July 18, 2016

Neil Bosworth,
Tonto National Forest Supervisor
2324 East McDowell Road
Phoenix, AZ 85006

RE: Scoping Comments for the Resolution Copper Mine DEIS

Figure 1. Resolution's geochemical testing schematic showing the test, resulting information, and sample selection criteria.

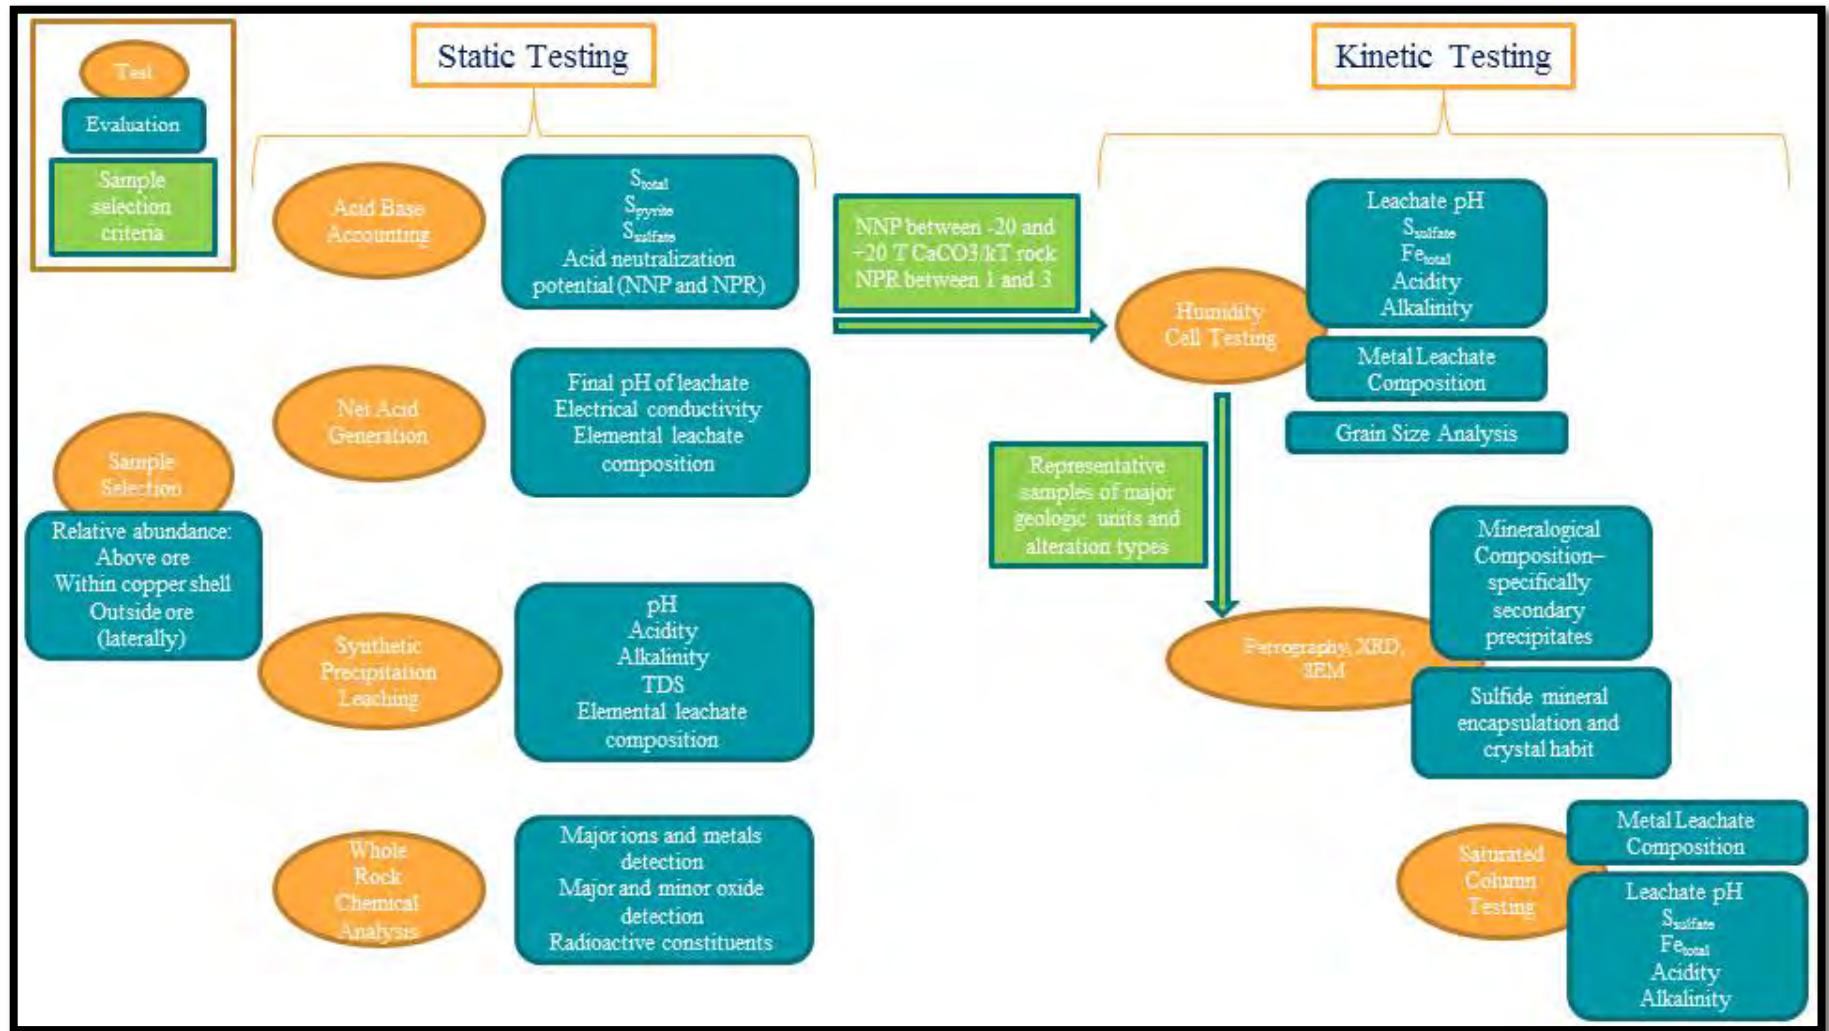
The testing progression (Figure 1) and sampling procedure (Figure 2) used by Resolution to gather geochemical data for mine waste show the range of qualitative and quantitative information (seven AMD prediction tests run) and the large sample set used for analysis (239 samples). The progression from static to kinetic testing involves a reduction in sample size based on the selection criteria for the Humidity Cell (Net Neutralization Potential between -20 and +20 T CaCO₃/kT rock and Neutralization Potential Ratio between 1 and 3). The sample set was reduced by 77% after selection for kinetic level testing (239 to 54 samples), and again reduced by 74% after selection for the Saturated Column Leach Test (54 to 14 samples).
